Trends in ecosystem and health responses to (reductions in) long-range transported atmospheric pollutants

To be discussed in Geneva - to all ICP's

• **Figure X** Calculated relative changes in corrosion due to SO_2 for the IPCC RCP2.6 scenario.

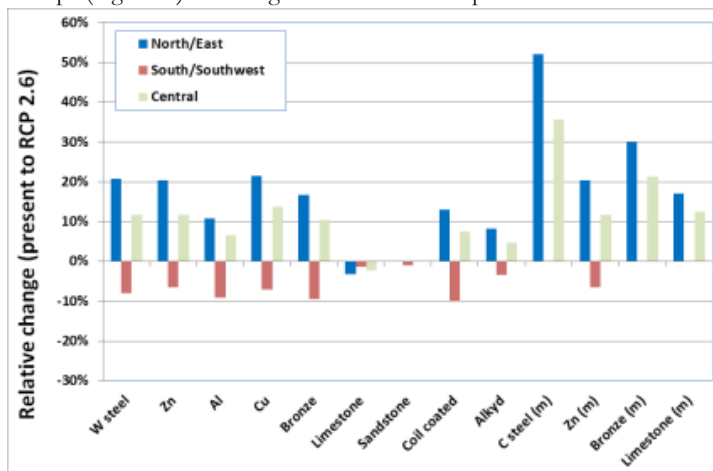
Comment [HWI5]: We can't have new figures in the summary. Is it possible to add this figure to the results?

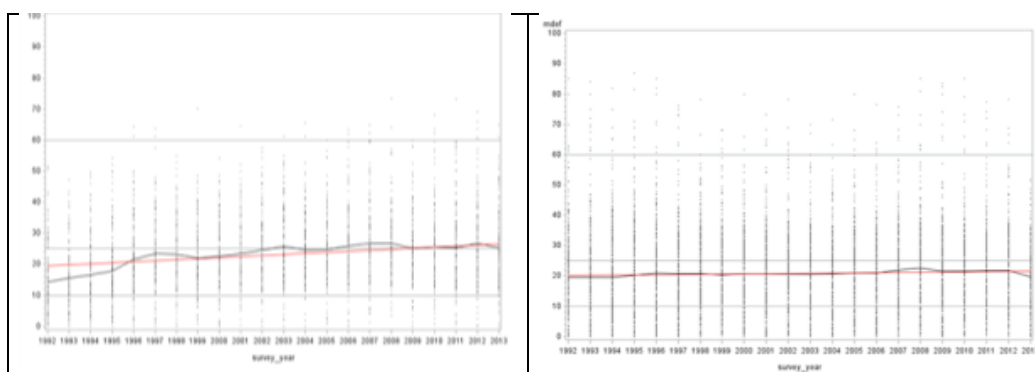
Comment [HWI18]: The font is too small, the figure is very difficult to read.

Comment [HWI19]: So, an upward trend in crown condition is good? This is confusing. What is on the y-axis? Defoliation?

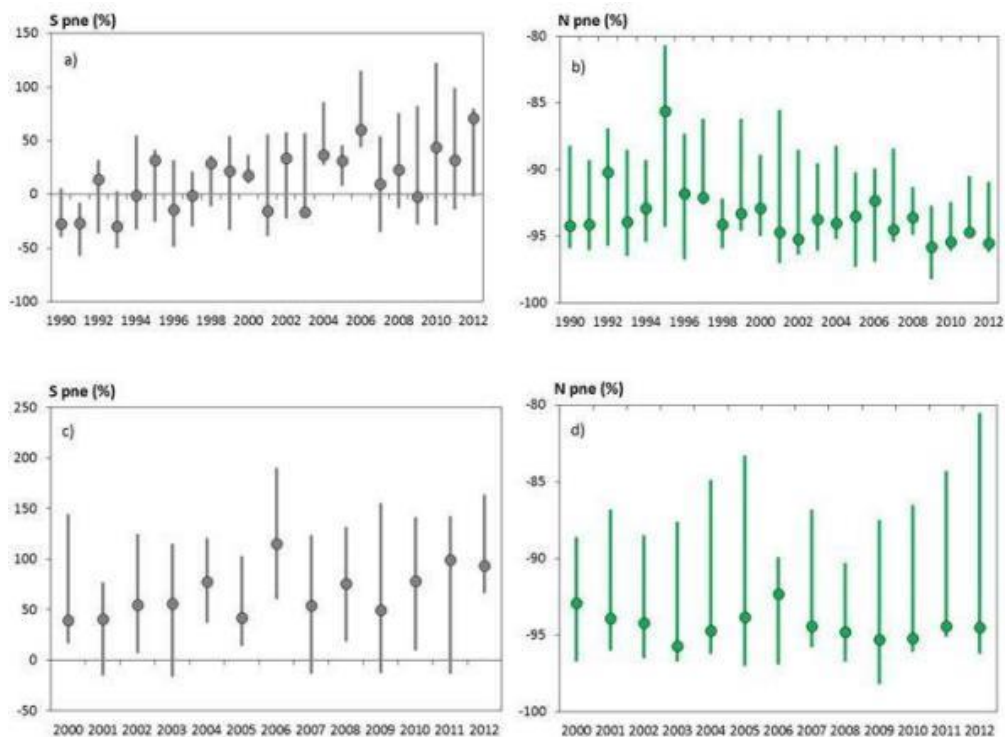
Comment [HWI24]: Is it possible to refer to a paper for most of the technical information here? I find 'S pne' a bit hard to understand – why not write 'Ratio of catchment input to catchment output for S and N (in %)'? Why show both 1990-2012 and 2000-2010? Please pick the graph with the longest period.

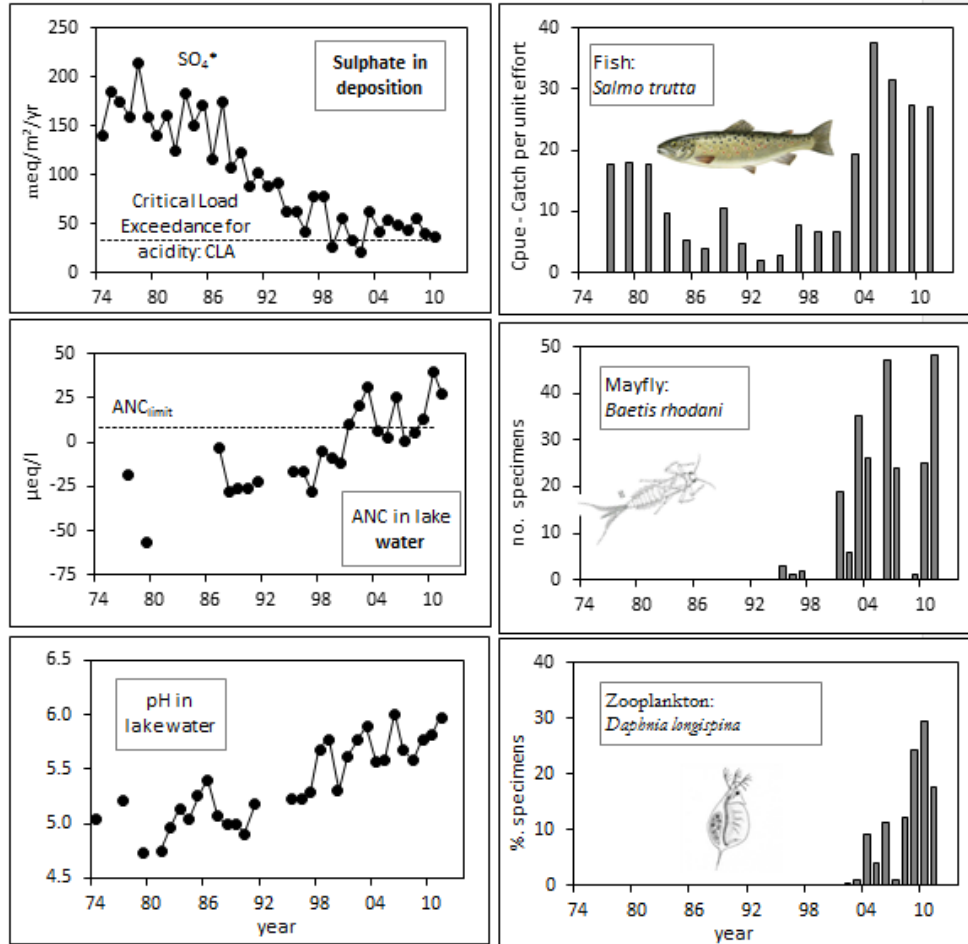
Comment [HWI25]: Remove? It is a bit different from the rest.

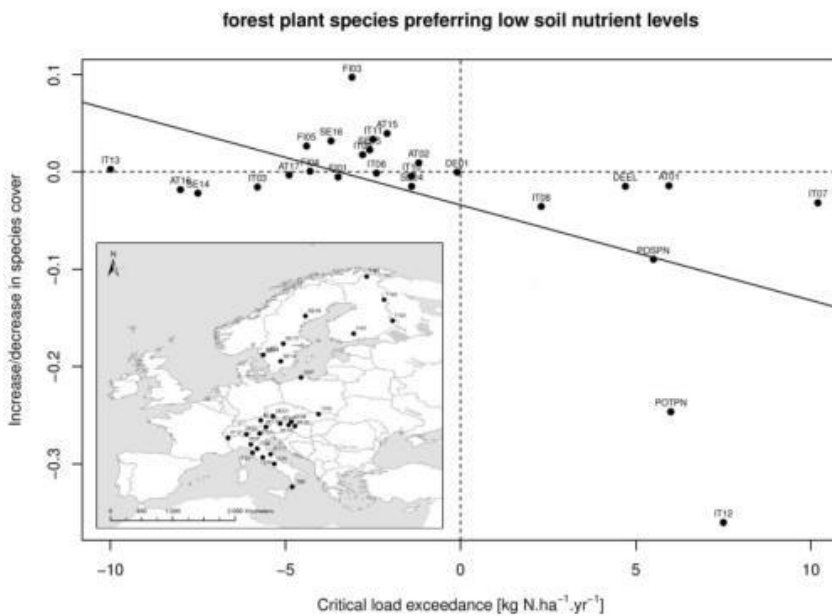
Comment [HWI29]: I don't understand? Doesn't the figure below document damage from airborne N dep on species diversity?

Comment [HWI30]: The fonts in this figure are very small.

Figure 4. Average median metal concentration in mosses for countries that reported metal data for at least four survey years since 1990 (1995 for arsenic; Harmens et al., 2015). The values in the graphs represent the percentage decline between 1990 (1995 for arsenic) and 2010.

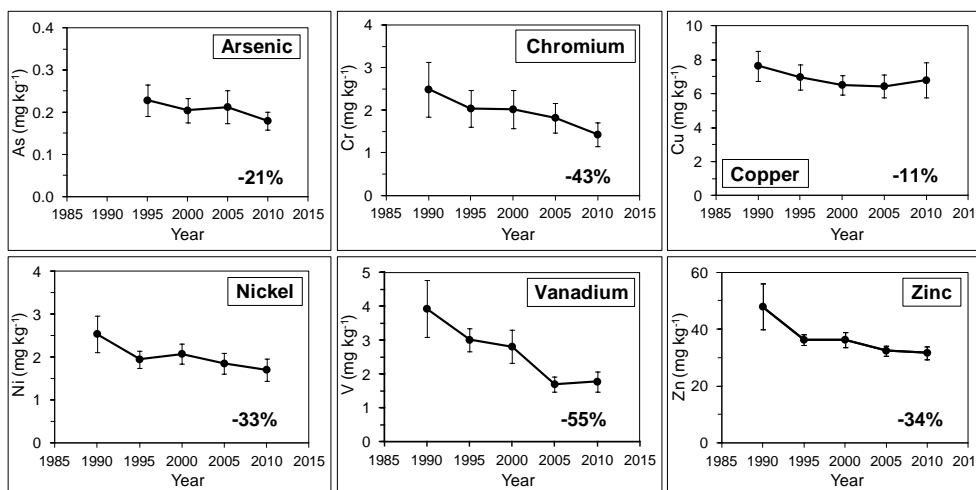
Comment [hh35]: This figure could be omitted.

Figure 3.3.5_2. Stream water Cd and Pb (mg L^{-1}) and Hg (ng L^{-1}) concentrations at European ICP IM sites in six countries. Error bars indicate 10th and 90th percentiles of annual metal concentrations from each site.

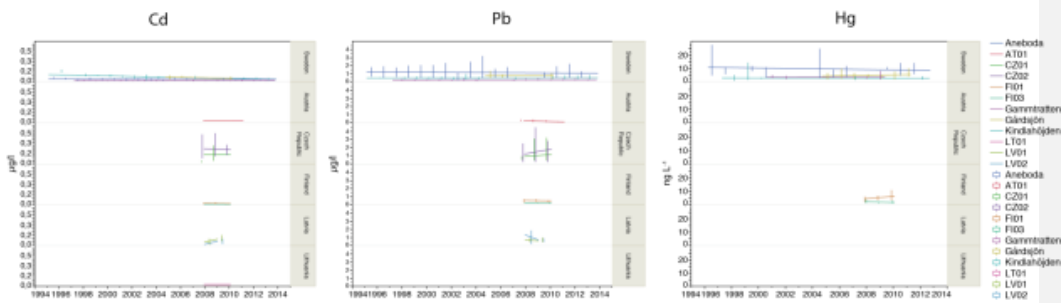
Comment [HWI37]: I suggest to leave out the sites where you don't have enough data to do a trend analysis. Look at figure above to improve the figure. Can you leave out all the site ID's? Just refer to a report instead?

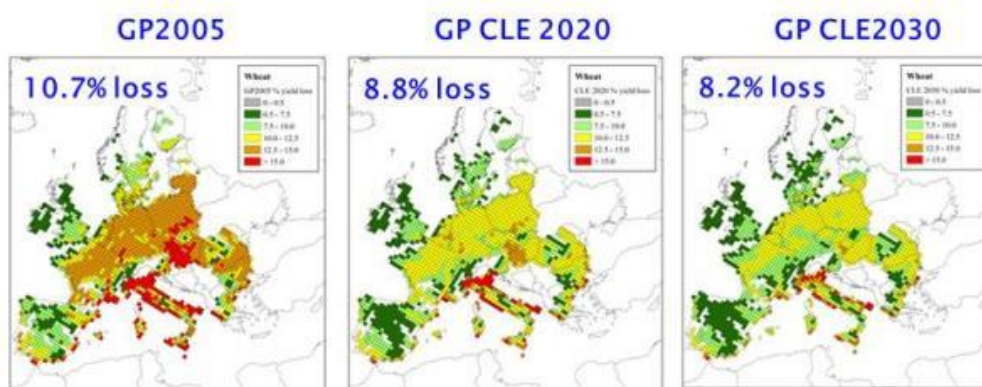
Comment [hh40]: Could be omitted.
